**Referral To PCZBA Text Amendment(s)**

**Min Scenic Corridor; Min Lot Sizes & Max Setback Relief**

MEMORANDUM

|  | SCALE: 1" = 100'<br> | PROJECT:<br><b>STEINBACH PROPERTY</b><br>LONG GROVE, IL | PROJECT NO.: 1871<br>DATE: 08/20/15 |

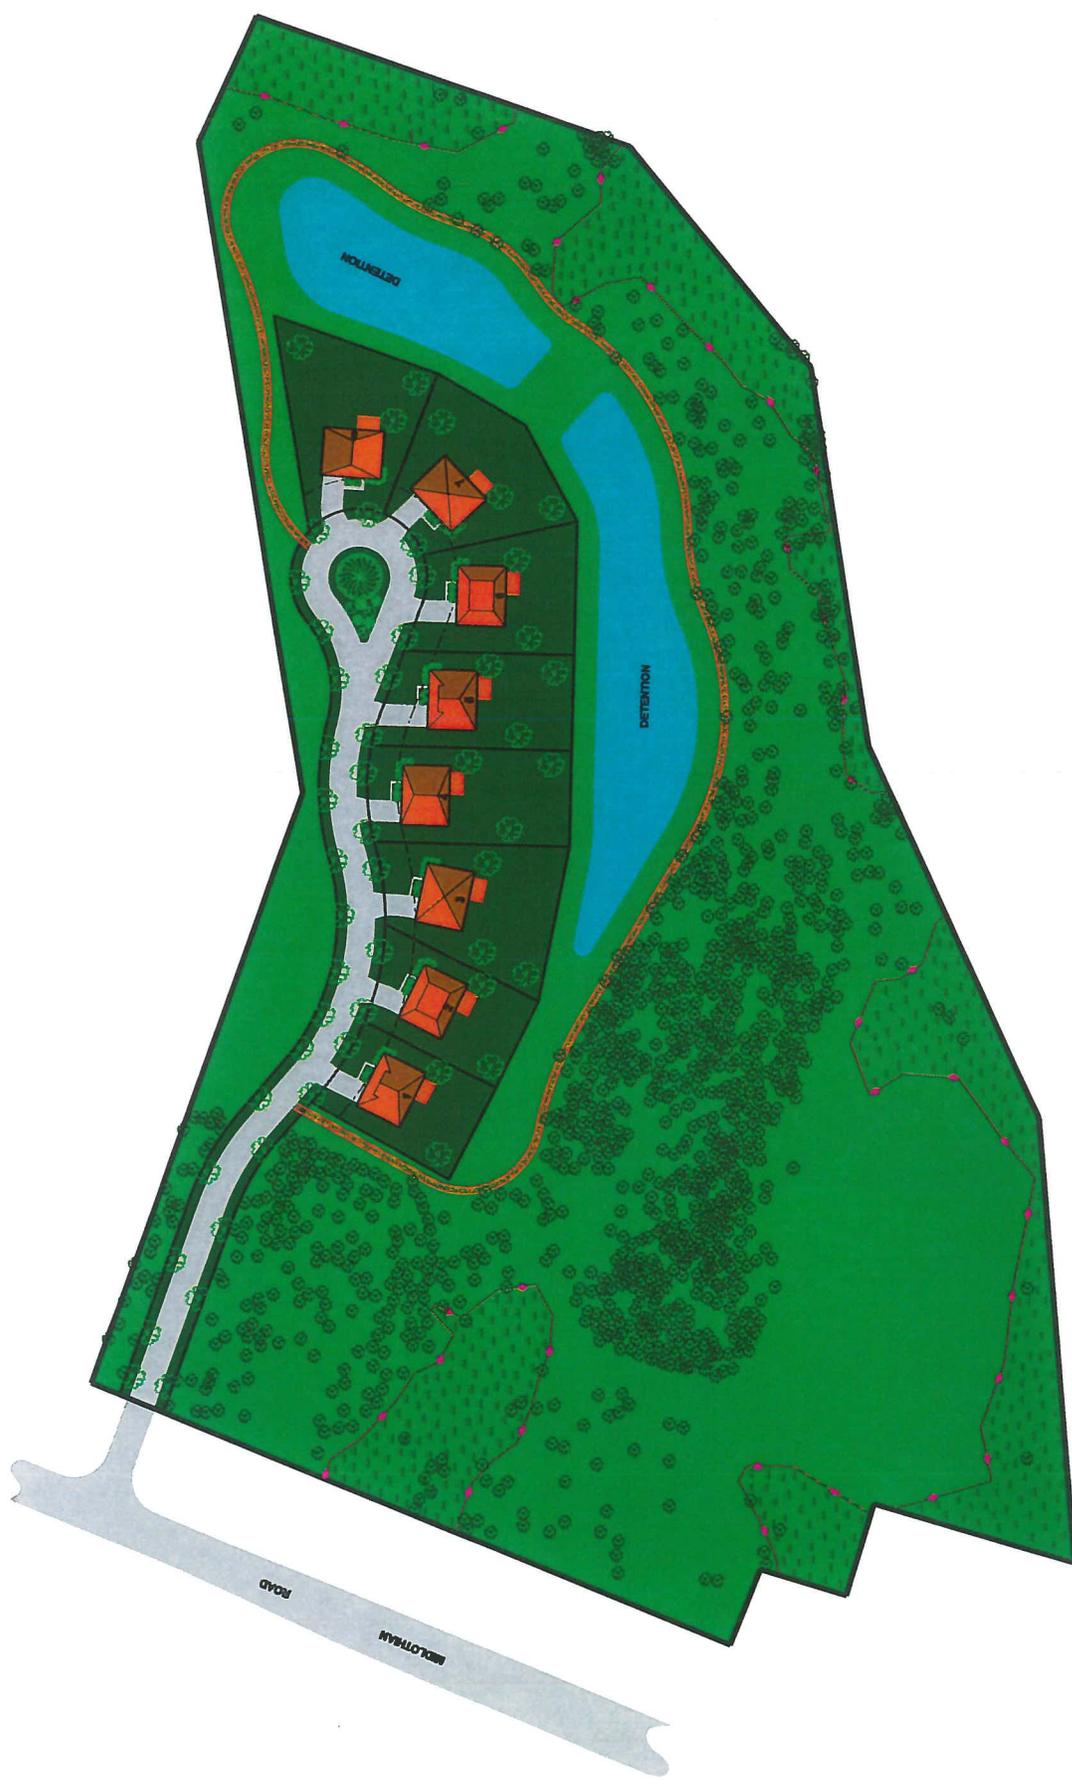
The development would be comprised of 8 lots on 16.77 acres for and overall site density of 2.1 acres per unit. Lot sizes would be between 10,310 sq. ft. & 14,450 sq. ft. with an average lot size of 12,706 sq. ft. This is well below the 33,000 sq. ft. lot size mandated by the subdivision code and PUD regulations. Approximately 4.14 acres of site would be utilized for development the remaining 12.63 acres would be kept as open space. ( See attached site plan.)

Setback relief beyond the 20% maximum provided for in the PUD regulations is required.

Scenic Corridor requirements along right-of way acquired for the Rt. 53 extension are also not met.

In addition the ROW for the RT 53 extension abuts the NE side of the property. As this constitutes existing ROW a 100' foot scenic corridor would be required along this ROW as well. As this is not identified on the submitted plans and no provisions for variation are made in the current code a text amendment appears to be required. Again per the Village Code;
